**Panel Report**

**Cardinia Planning Scheme Amendment C234  
Pakenham East Precinct Structure Plan**

**10 September 2018**

Panel Report pursuant to section 25 of the Act

**Figure 5** Revised Parklea alternative Future Urban Structure Plan

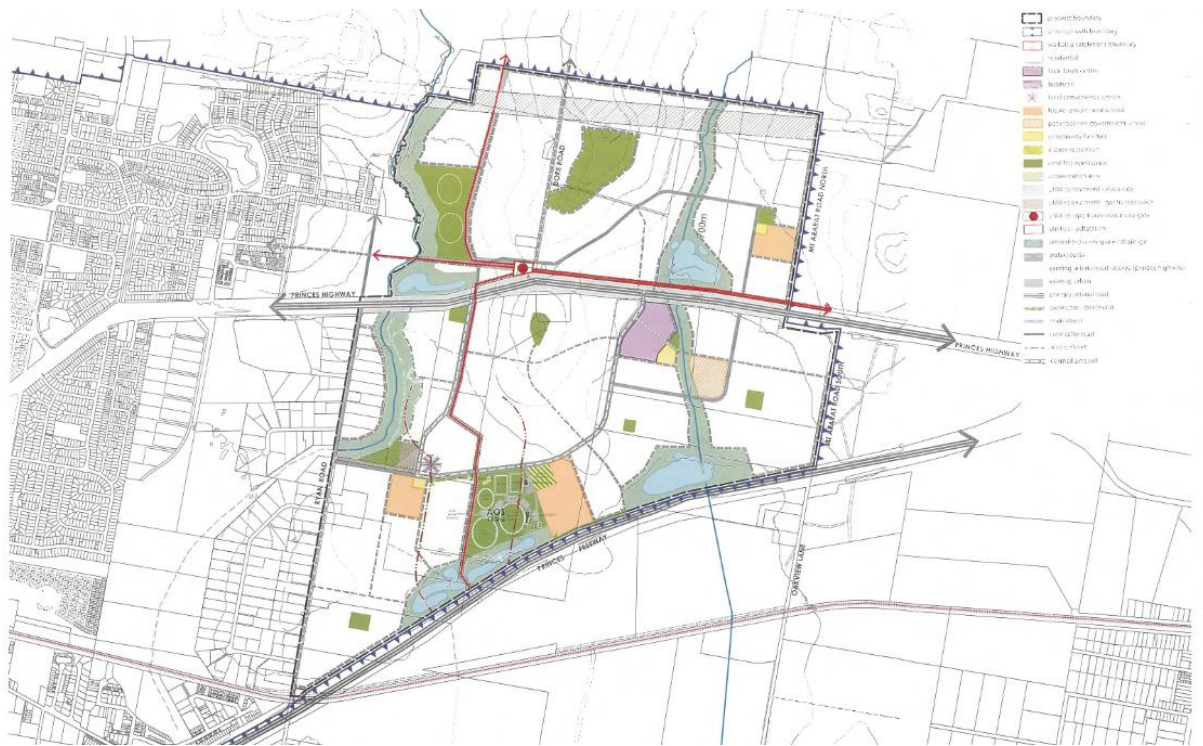
At the conclusion of its submission Parklea presented a revised alternative FUS (Document 92) which proposed a single open space area co-located with the school and indoor sports facility in a similar location to the exhibited FUS but moved further west to abut the boundary of the gas easement (Figure 5).

The VPA responded to this revised alternative FUS as follows:

**Figure 7:** VPA proposed diagram for inclusion in the Final List of PSP Changes

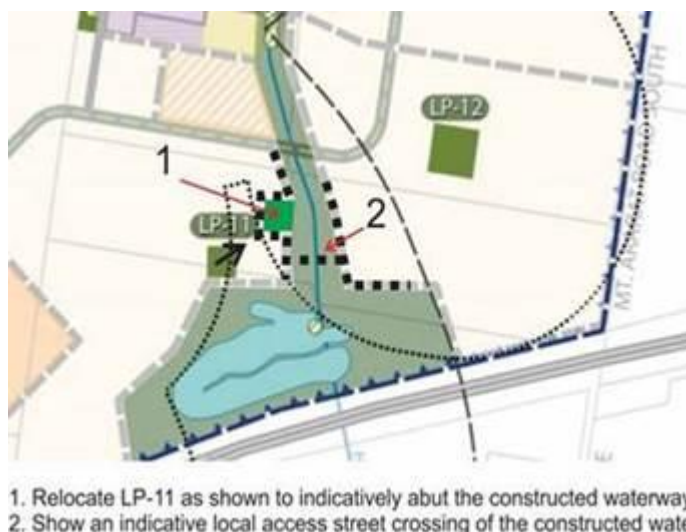
In addition, the response from the VPA agreed to include the following diagram (Figure 7) in the Final List of PSP Changes.

- The Final List of PSP Changes should be amended to include the changes to requirement R79 and the addition of Figure 7.

##### 13. Amend Plan 3 – Future Urban Structure of the Pakenham East Precinct Structure Plan by adding a diagram as shown in Figure 7 of this report.
